My name is Walter Borek. My family and I have lived at 4833 Alton Place for the last 29 years. We live 273 paces, a 2 minute and 13 second walk, .08 of a mile by air and .15 miles by foot from the proposed development site.

4330 48th Street NW case #16-23 january 25th, 2018

ELEVATION OF DEVELOPMENT FACING THE 49TH AND MASSACHUSETTS AVENUE INTERSECTION

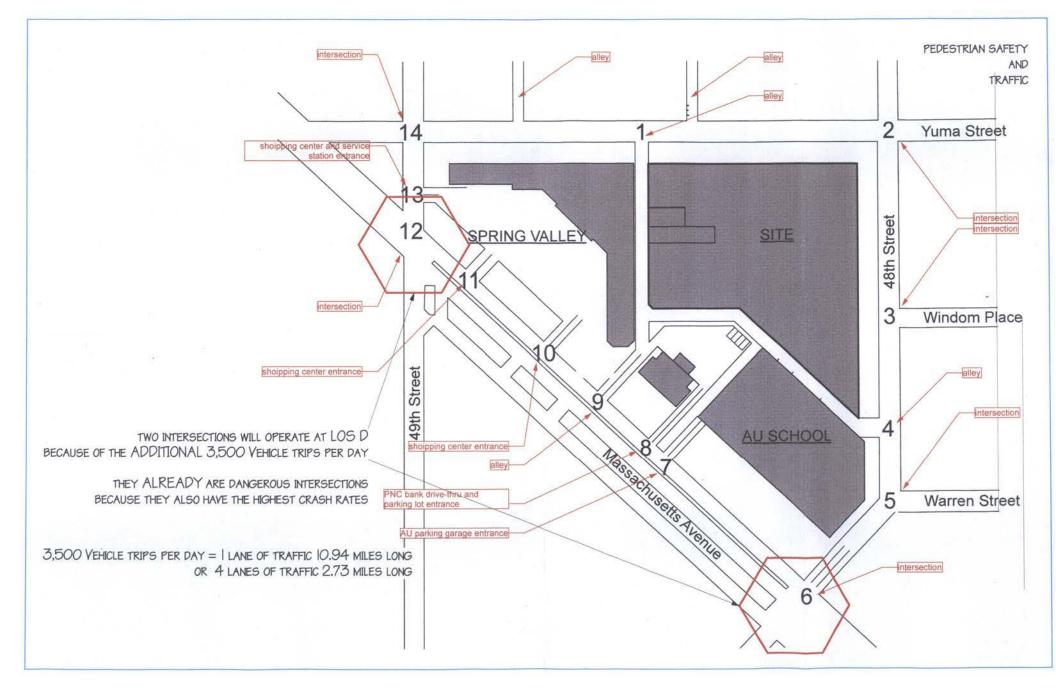
This development is both a 4 to 5 story, Second Empire, Mansard-roofed, 20 unit condo building <u>and</u> a massive 5 to 8 story, Neo-Something Classical, Tenement Revival apartment building of 200 residential units.

This development is a massive 8 story "BILLBOARD", overwhelming the Historically Designated Spring Valley Shopping Center and destroying the Massachusetts Avenue Portal

PEDESTRIAN CIRCULATION PLAN IN BLUE

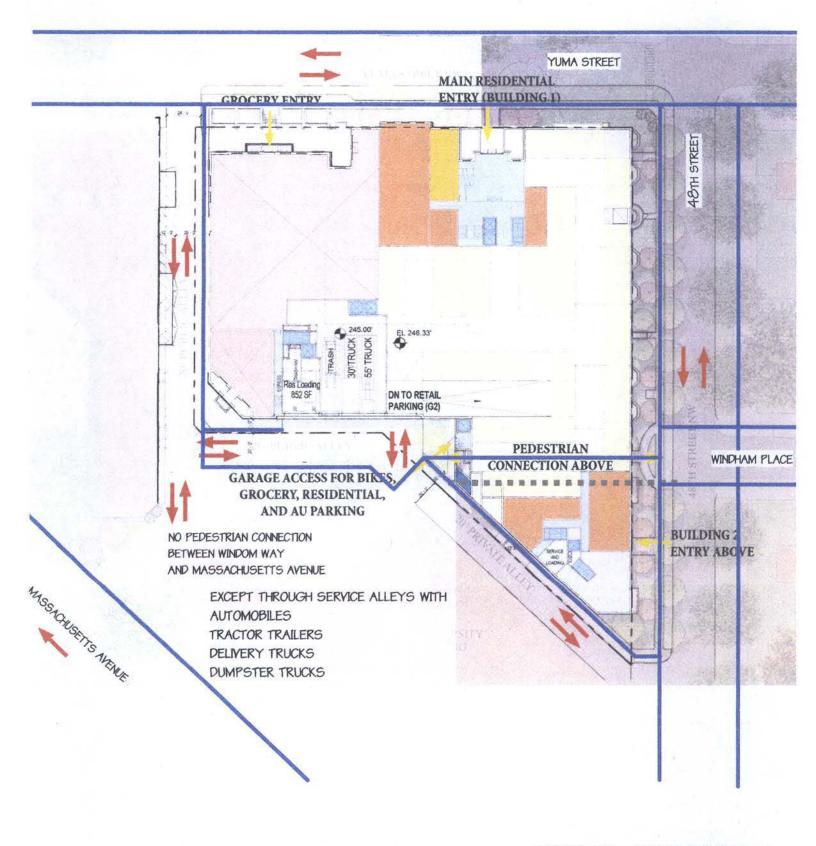
It relies almost entirely on an internal Service-Alley system of circulation of tractor trailers, service trucks, dumpster service, and automobiles that <u>pedestrians</u> are encouraged to use.

The only true pedestrian path is Windom Walk

a short alley-like landscaped space running from 48th Street to an alley to another alley to Massachusetts Avenue.

There is no pedestrian way to Massachusetts Avenue unless the pedestrian goes thru trucks, dumpsters, autos, alleys, driveways, service areas......

VEHICULAR CIRCULATION PLAN IN RED

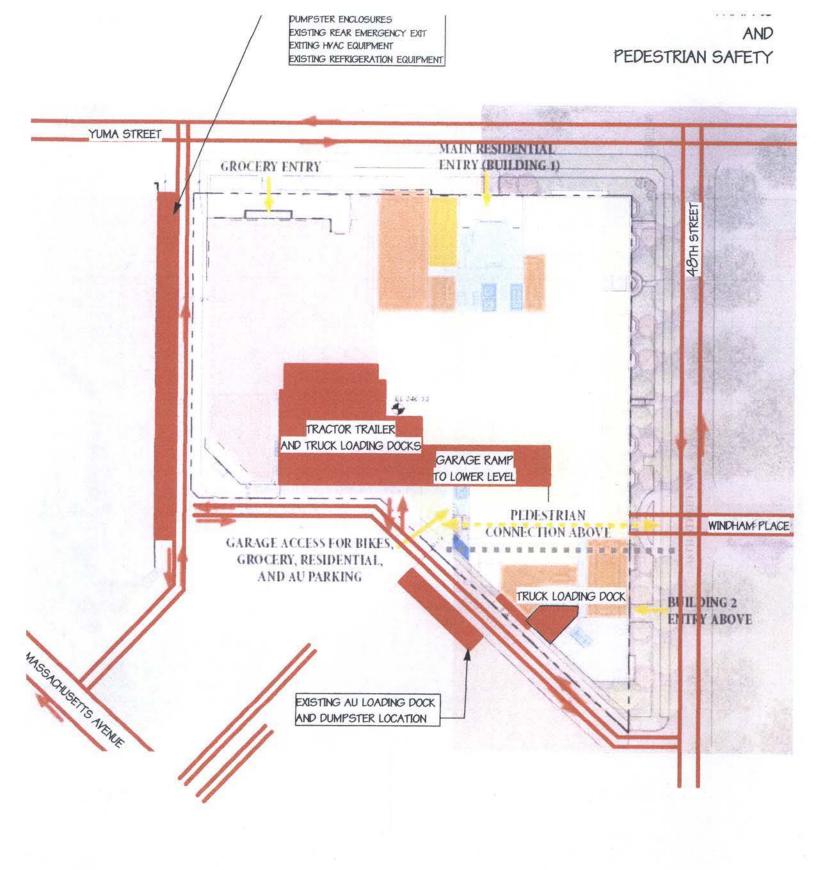
It's Unsafe and Irresponsible

ELEVATION OF DEVELOPMENT BEHIND SVSC FACING THE 49TH AND MASSACHUSETTS AVENUE INTERSECTION

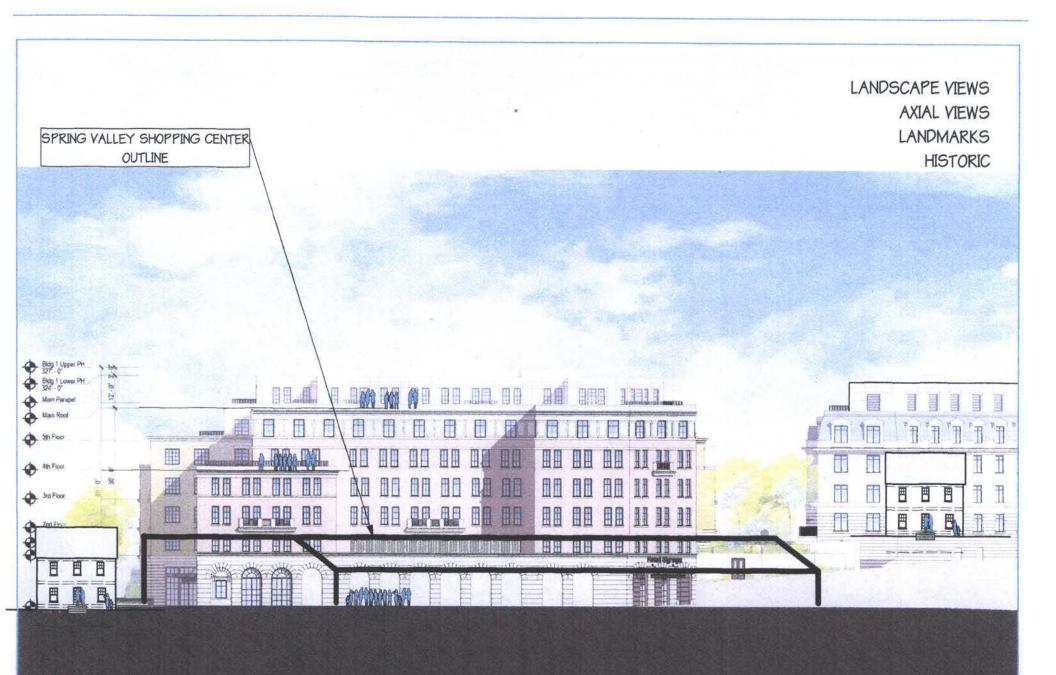
one of the two widest boulevards in the District at 160'. Pennsylvania Avenue is the other. The proposed development would destroy this tree-lined gateway to our city.
